**ADDENDUM  
NO. 1**

**March 17, 2025**

**PORTER LAKES ELEMENTARY SCHOOL  
ADDITION, RENOVATIONS, AND RELATED WORK  
Hebron, IN 46341**

This Addendum consists of Pages ADD 1-1, Specification Section 00 34 10 – Responsible Bidding Practices, and attached Addendum No. 1 from Gibraltar Design, Inc. dated March 14, 2025 and consisting of 6 pages, Specification Section 07 41 13 – Aluminum Roofing and 28 drawings.

DRAWING GENERAL NOTES, SYMBOLS, ABBREVIATIONS, AND PARTITION TYPES

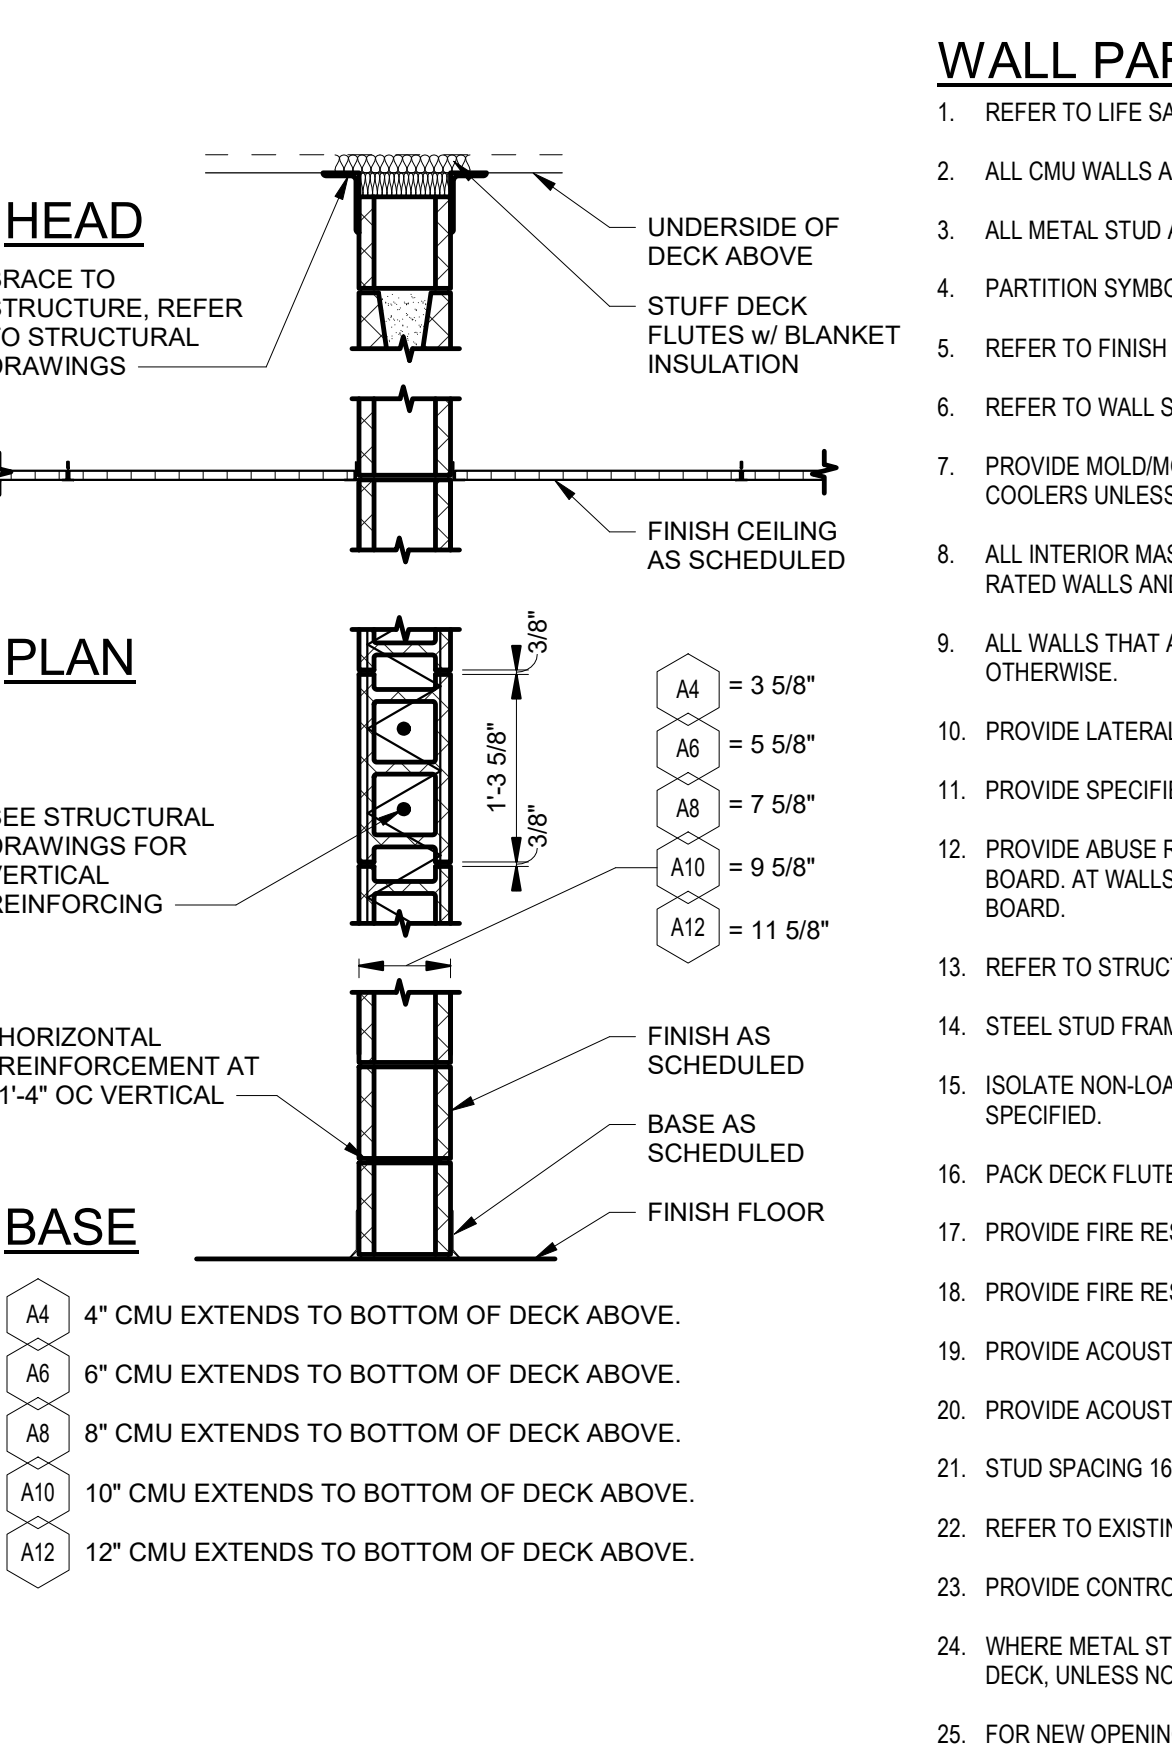
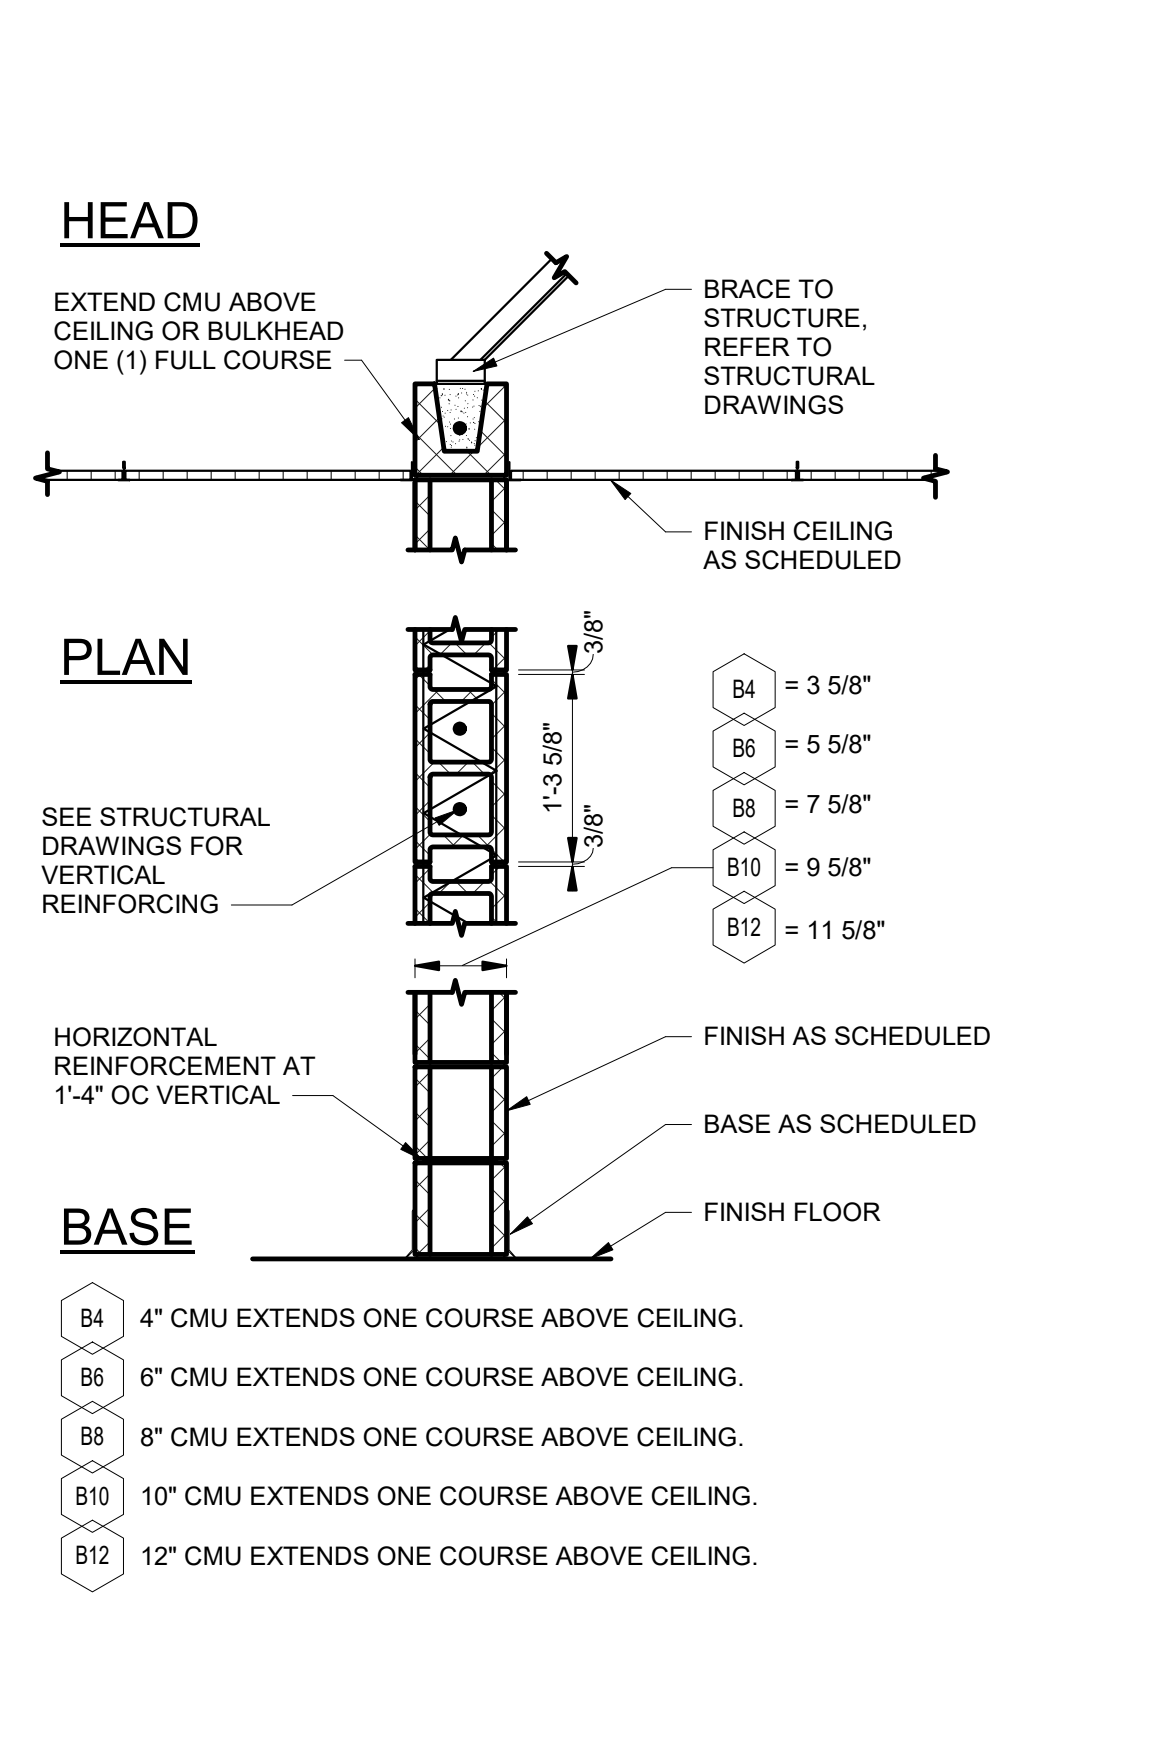
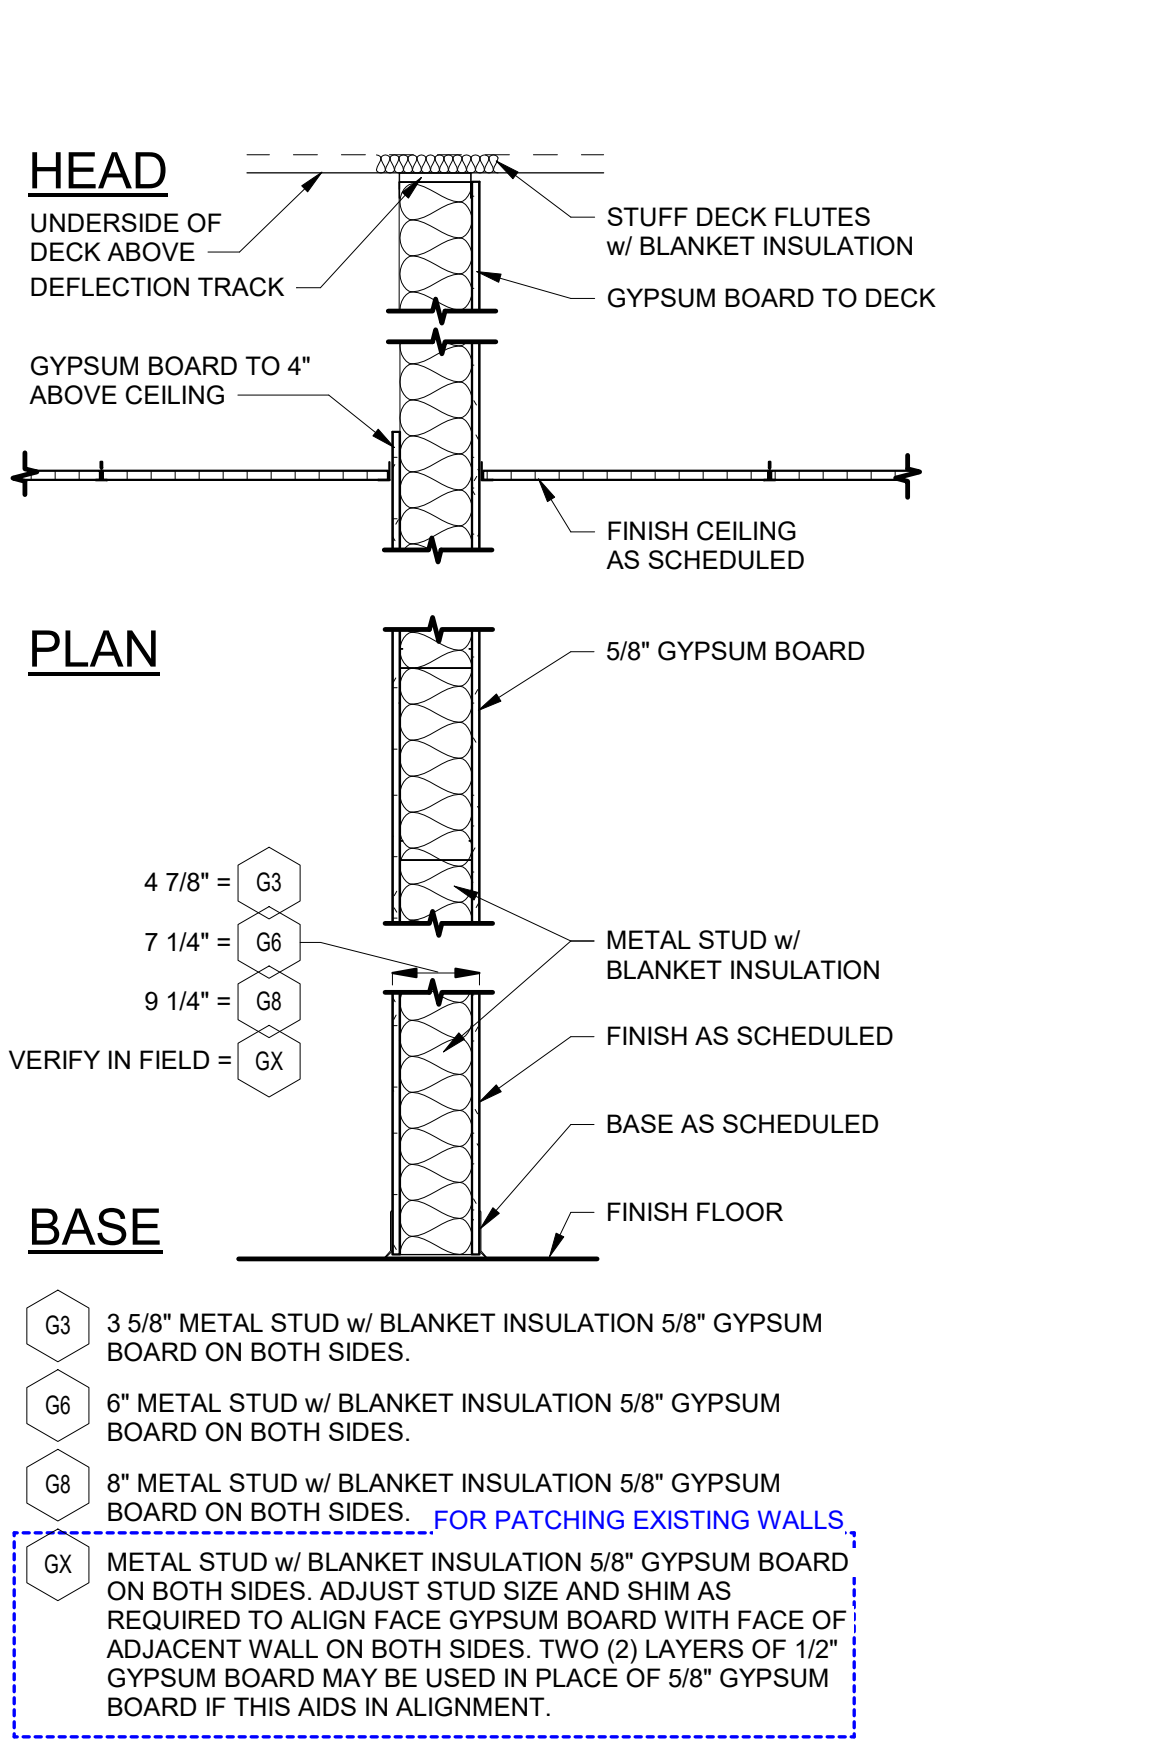
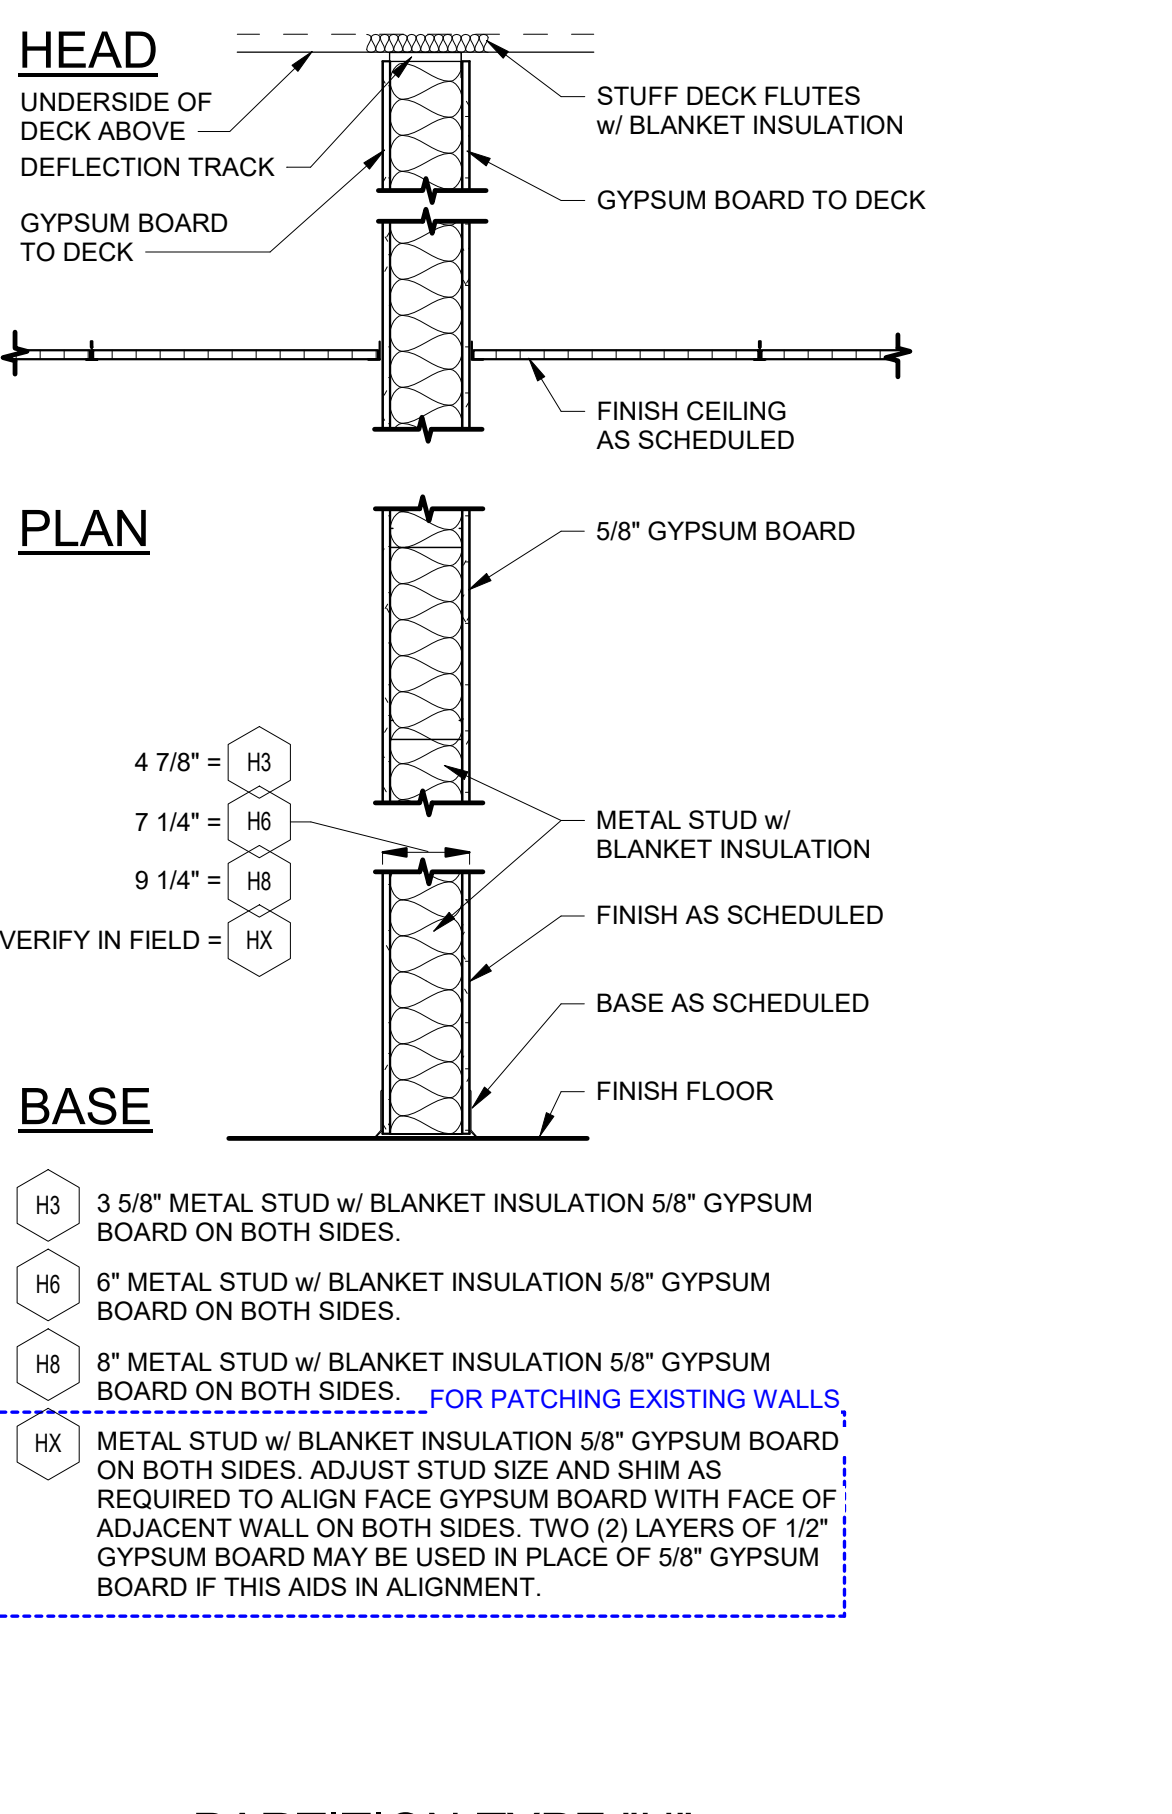
3. **Sheet G-101**
  - A. Revise the title for Sheet G-301 to read "GENERAL NOTES, SYMBOLS, ABBREVIATIONS, AND PARTITION TYPES".
4. **Sheet G-301**
  - A. Refer to revised, full-size drawing, included in this Addendum, for revisions.
    1. Renamed the sheet "GENERAL NOTES, SYMBOLS, ABBREVIATIONS, AND PARTITION TYPES"
    2. Added symbols, Material Indications, and General Notes
5. **Sheet C-1.1**
  - A. DEMOLITION NOTE 8, revise to read "REMOVE EXISTING METAL BUILDING AND CONCRETE FLOOR PAD. REFER TO ELECTRICAL SHEETS FOR RELOCATION OF ELECTRICAL FEED TO NEW METAL BUILDING TO THE WEST."
6. **Sheet C-4.1**
  - A. At RAMP DETAIL, remove dimensions and notes associated with the railing, and replace with a single note reading "NEW ALUMINUM RAILING. (REFER TO ARCHITECTURAL SHEET A-302)".
